WILLIAMSON COUNTY, TEXAS

CHANGE ORDER NUMBER: 1

Project:	<u>Forest North Phase 3</u>
Roadway:	<u>Drainage Improvements</u>
CSJ Number:	<u>3866</u>

Forest North Drainage Phase 3 Williamson County Project No. 3866

SHEET C-101
4 of 75

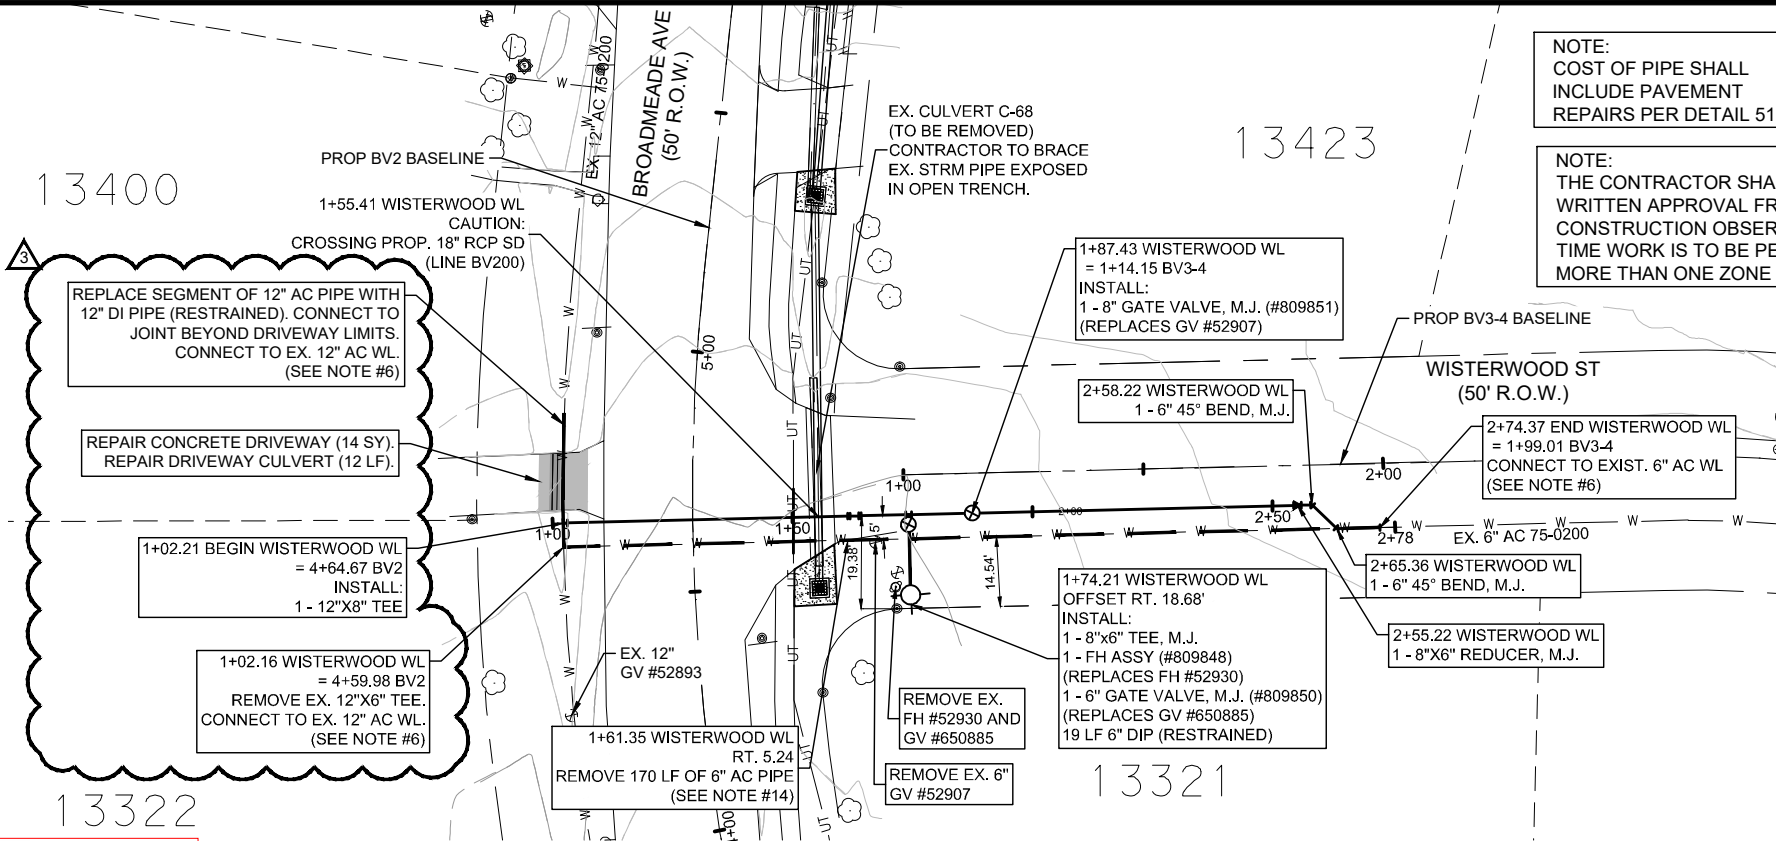
REV	NO.	REVISION DESCRIPTION	APPROVED	DATE
1	1	CHANGED DESIGN DUE TO DRN CHANGE	KV	2/10/2020
2	2	COMBINED BRAES VALLEY WL INTO ONE ALGN	KV	3/18/2020
3	3	CHANGED PERTSHIRE WL ALGN AND STATION	KV	6/17/2020
4	4	DUE TO FIELD CONDITIONS	KV	6/17/2020
5	5	CHANGED BRAES VALLEY WL "A" CONNECTION	KV	6/19/2020
6	6	DUE TO FIELD CONDITIONS	KV	6/19/2020

SHEET
C-104
7 of 75

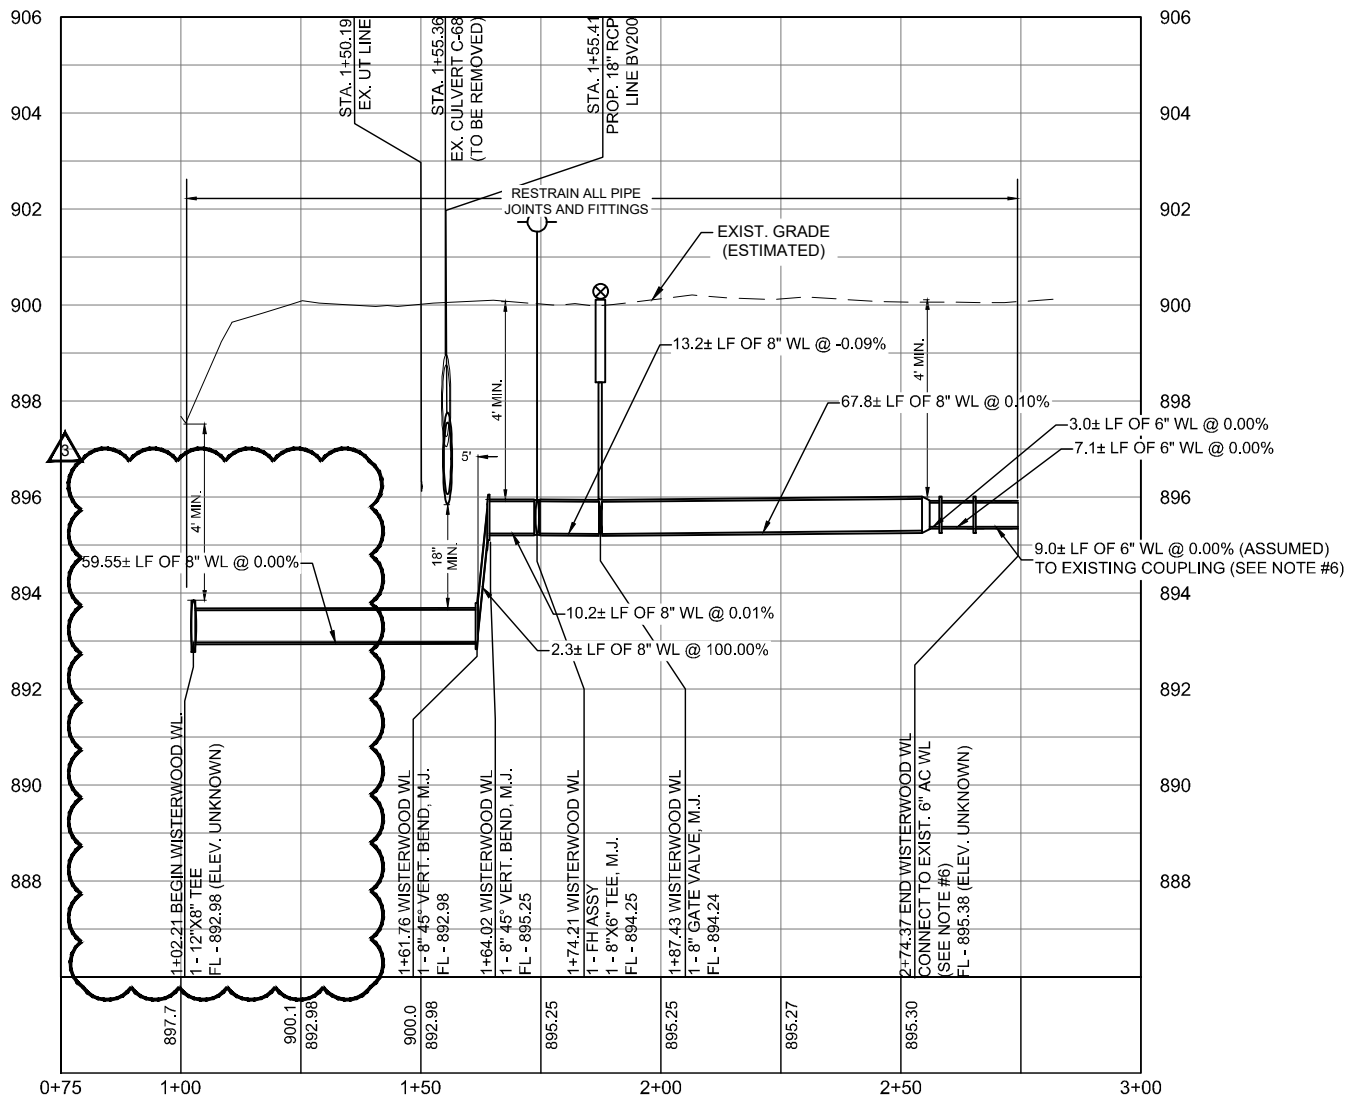
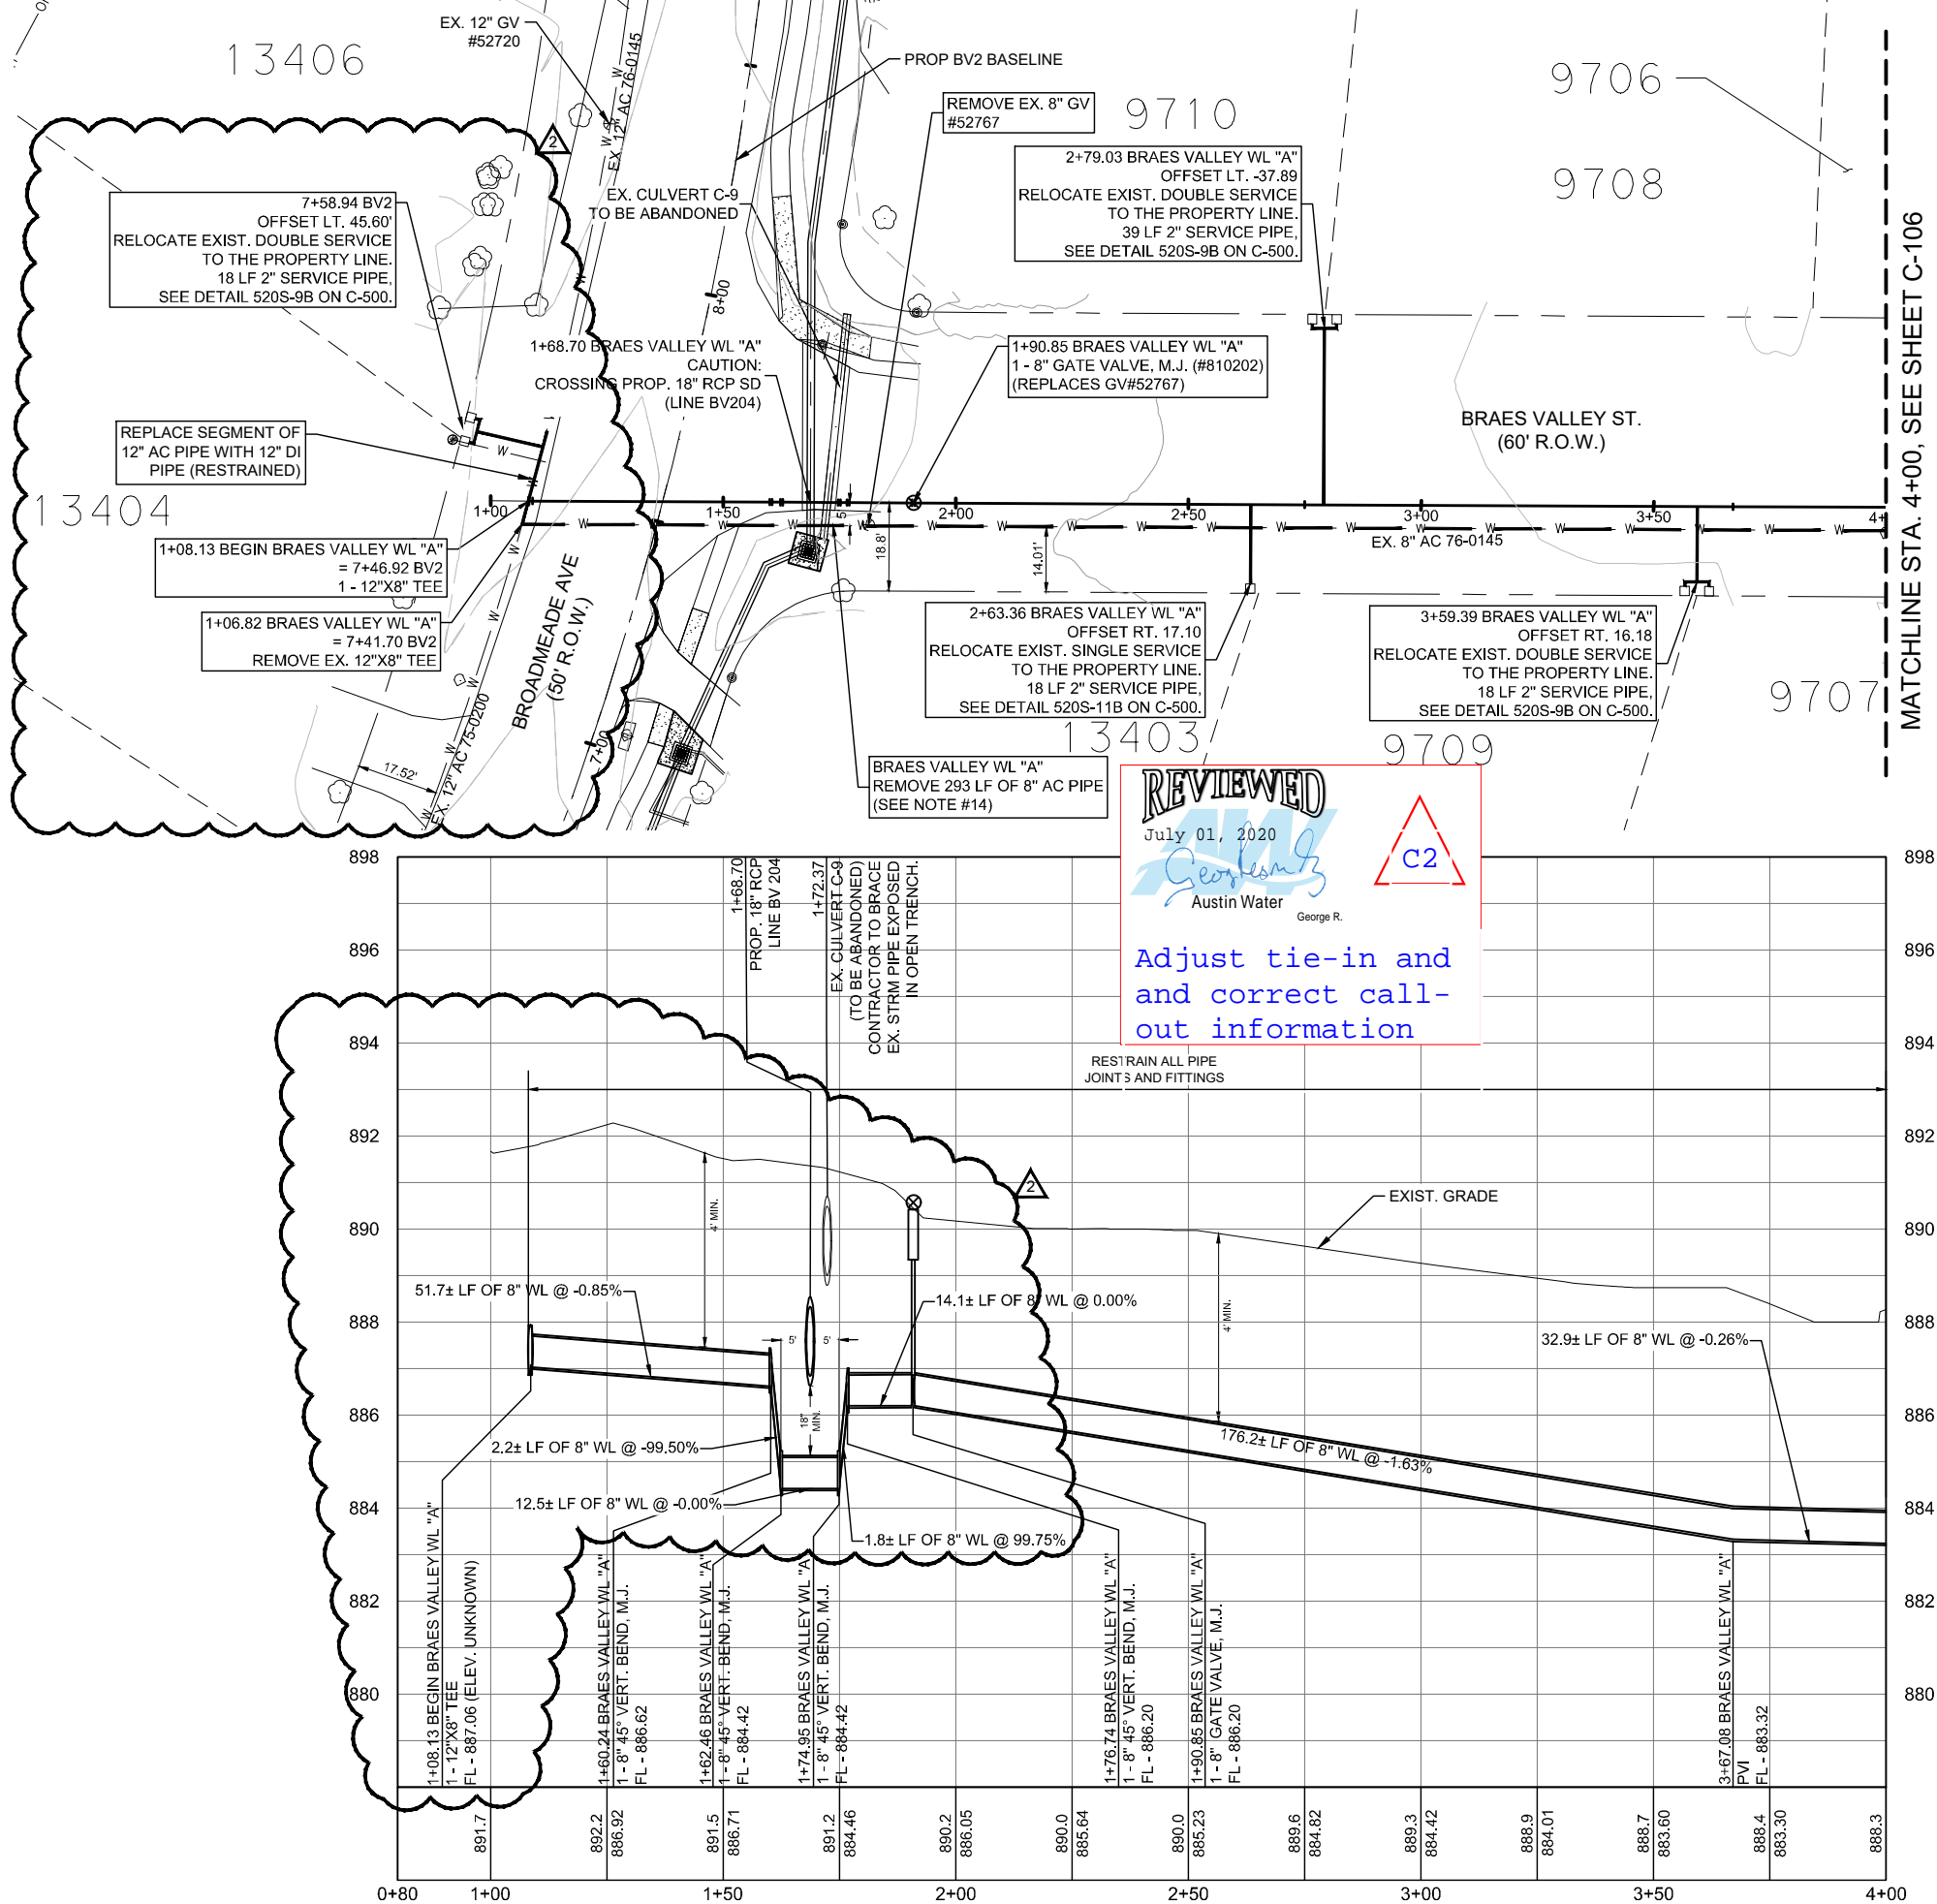
When potholing the existing water line on Broadmeade Avenue at Wisterwood Street, it was discovered that the existing COA water line is a 12" water line instead of an 8" water line as indicated in the plans. The 12" pipe removal, 12" pipe and connections will be added to the Contract. This Change Order also adds a new 2" Double Service connection for an existing service relocation. The pricing for the new items is considered fair and reasonable based on comparison to similar existing item pricing in the Contract and the small quantity involved.

REV. NO.	DATE	APPROVED BY	REVISION DESCRIPTION
1	7/20/2020	KV	CHANGED CONNECTION TO 12" WL DUE TO FIELD CONDITIONS

SHEET
C-105
8 of 75

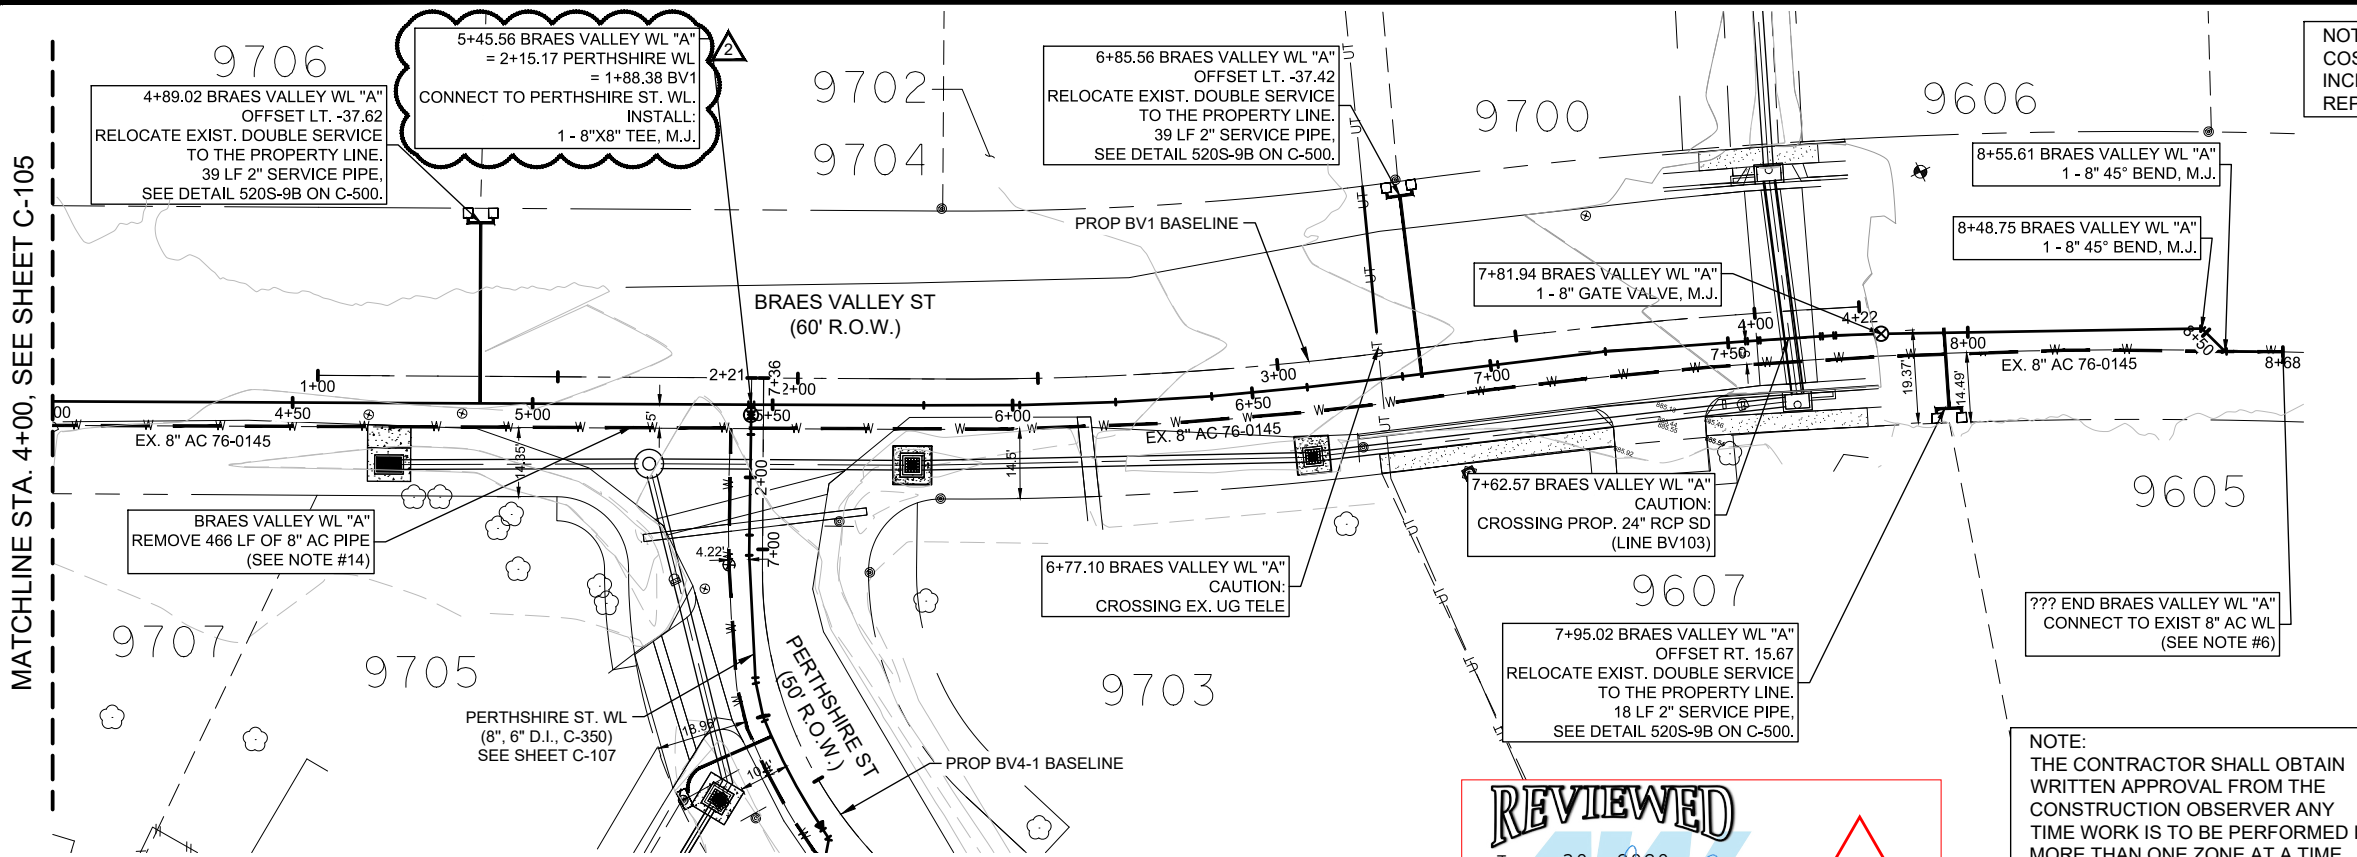
REV.	NO.	DESCRIPTION	DATE
1	1	CONSTRUCT BRAES VALLEY INTO ONE ALN	3/18/2020
2	2	CHANGED CONNECTION TO 12" WATERLINE	7/01/2020
3	3	ALONG BROADMEADE AVE
